**RE: Double Eagle Hangars – Phase 1
7401 Atrisco Vista Blvd NE
Grading & Drainage Plan
Engineer's Stamp Date: 08/01/23
Hydrology File: E05D003**

Based upon the information provided in your submittal received 08/02/2023, the Grading & Drainage Plan is approved for Building Permit and Grading Permit. Please attach a copy of this approved plan in the construction sets for Building Permit processing along with a copy of this letter.

Drainage Management Plan

TITLE: **DOUBLE EAGLE HANGERS
GRADING & DRAINAGE PLAN**

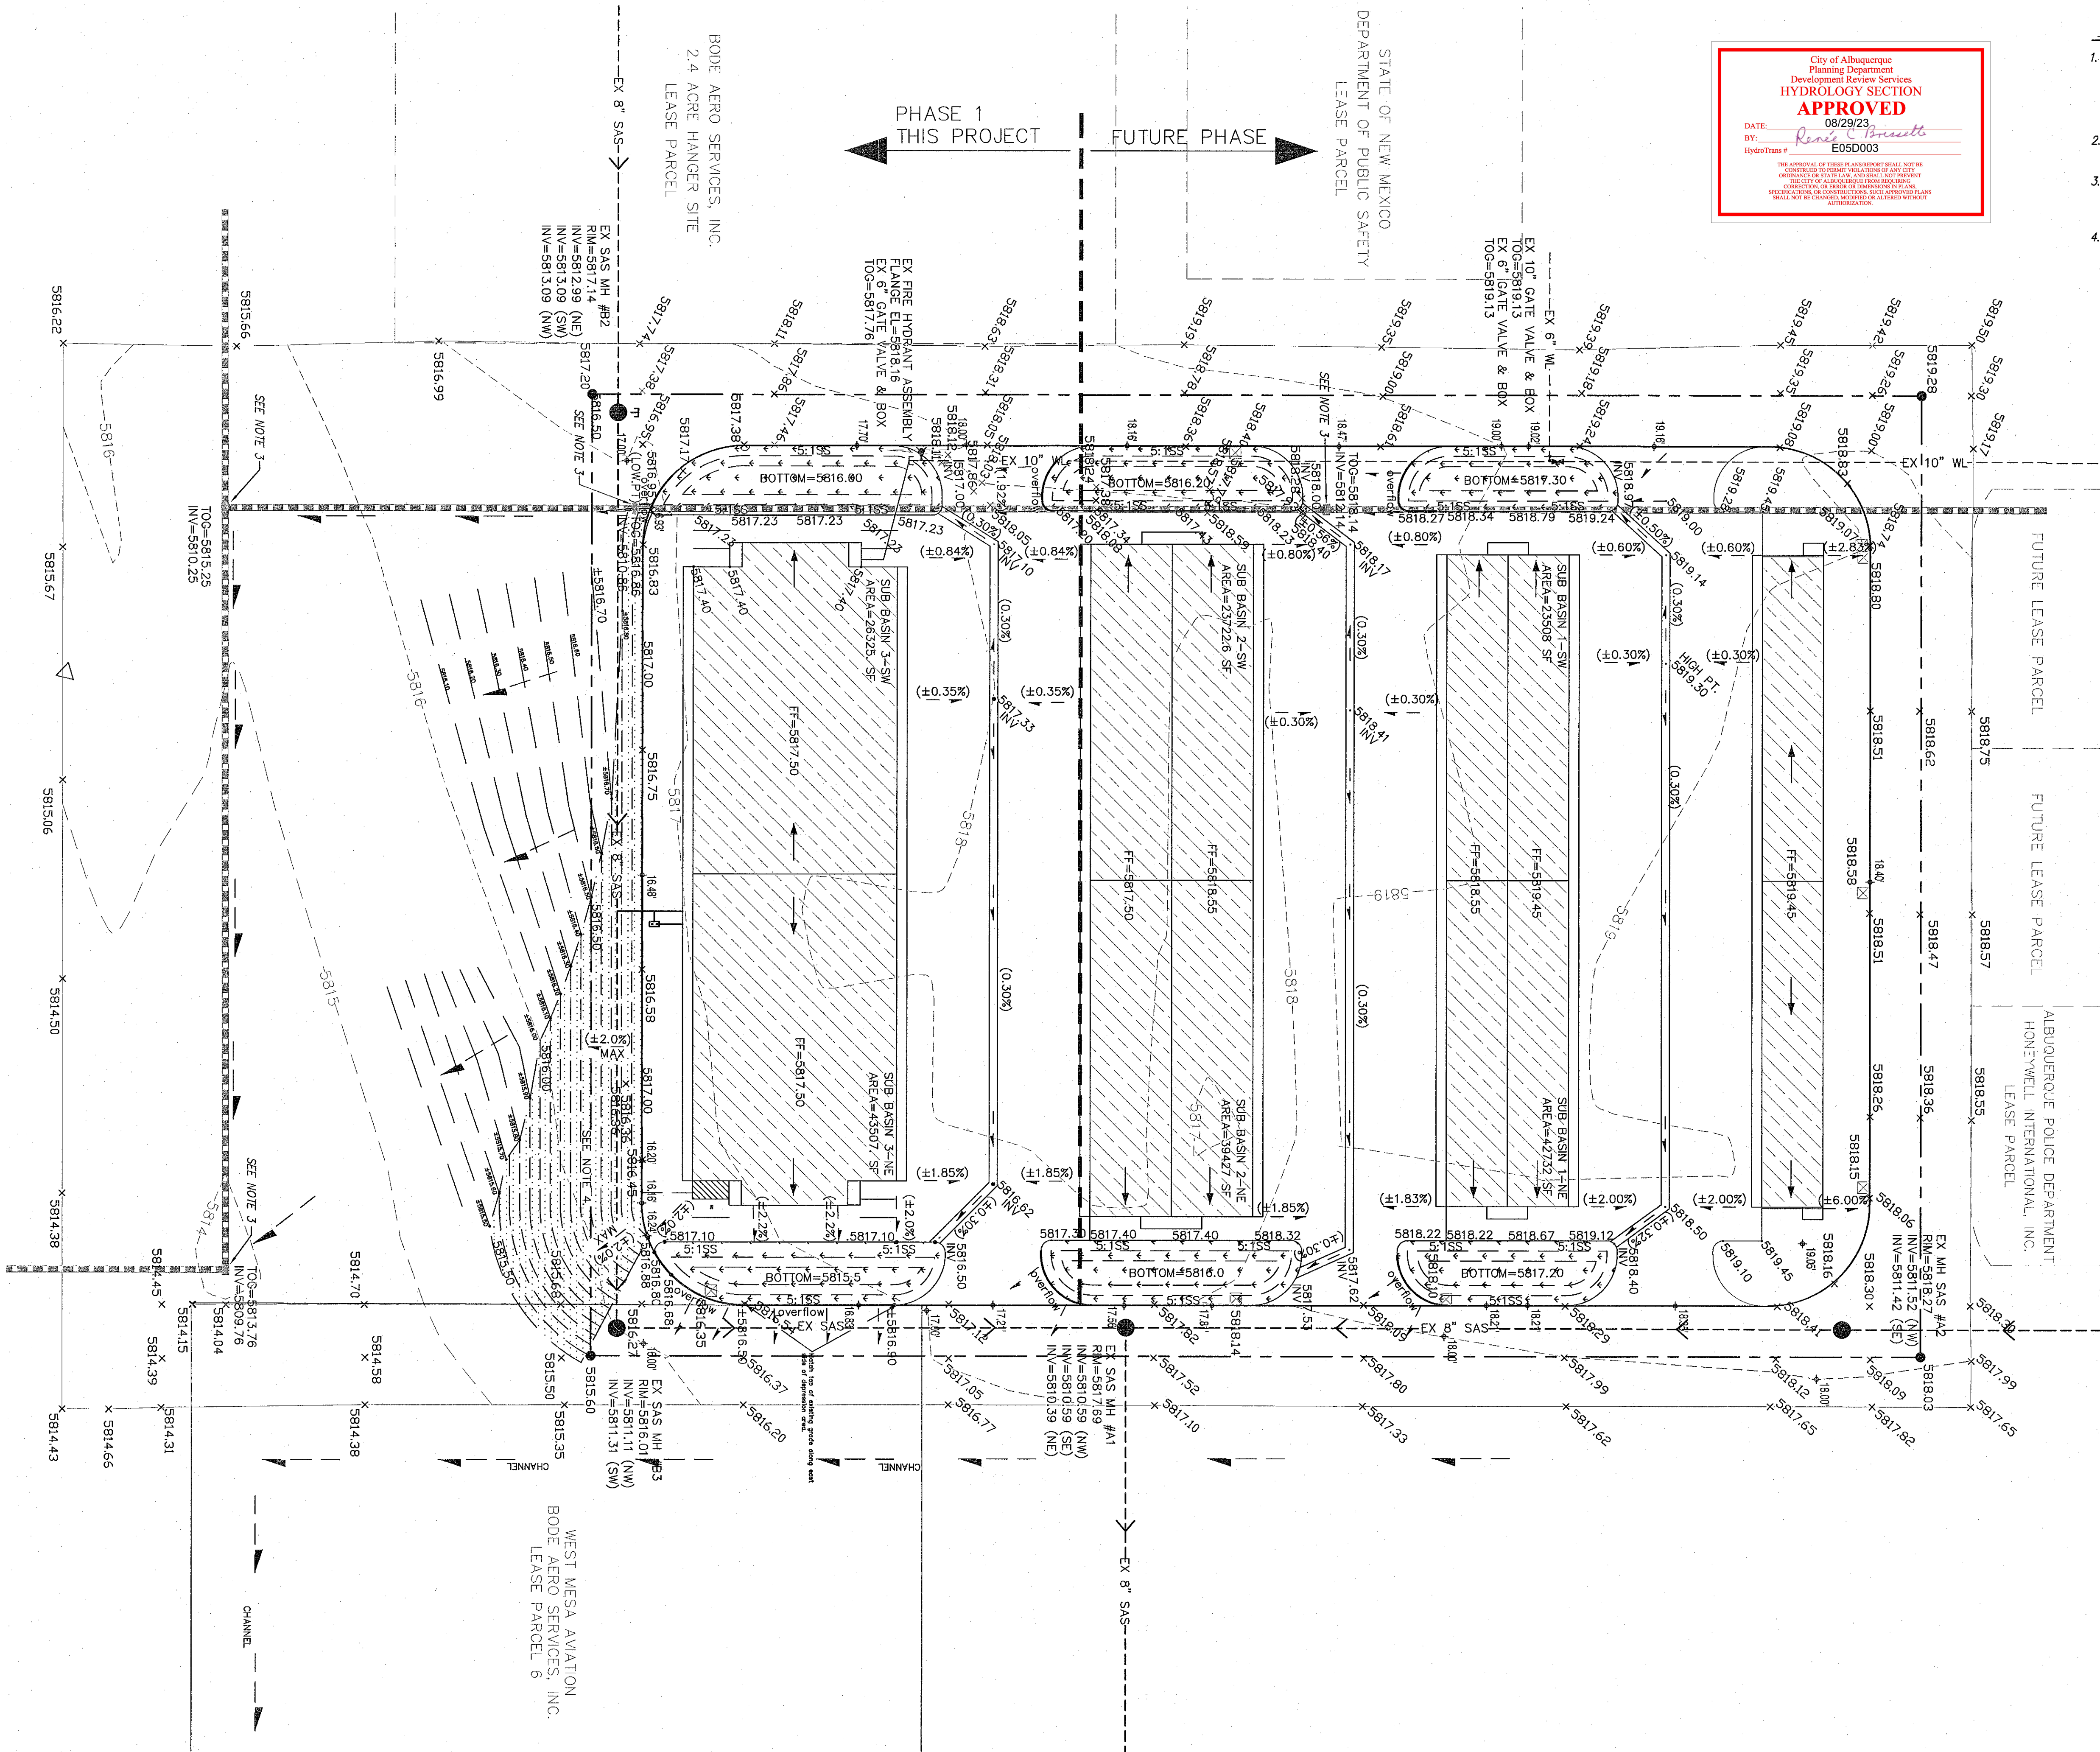
PRIOR TO CERTIFICATE OF OCCUPANCY:

1. Engineer's Certification, per the DPM Part 6-14 (F): *Engineer's Certification Checklist For Non-Subdivision* is required.

2. Please provide the executed paper Drainage Covenant (latest revision) printed on one-side only with Exhibit A and a check for **\$25.00** made out to "**Bernalillo County**" for the detention ponds per Article 6-15(C) of the DPM to Hydrology for review at Plaza de Sol.
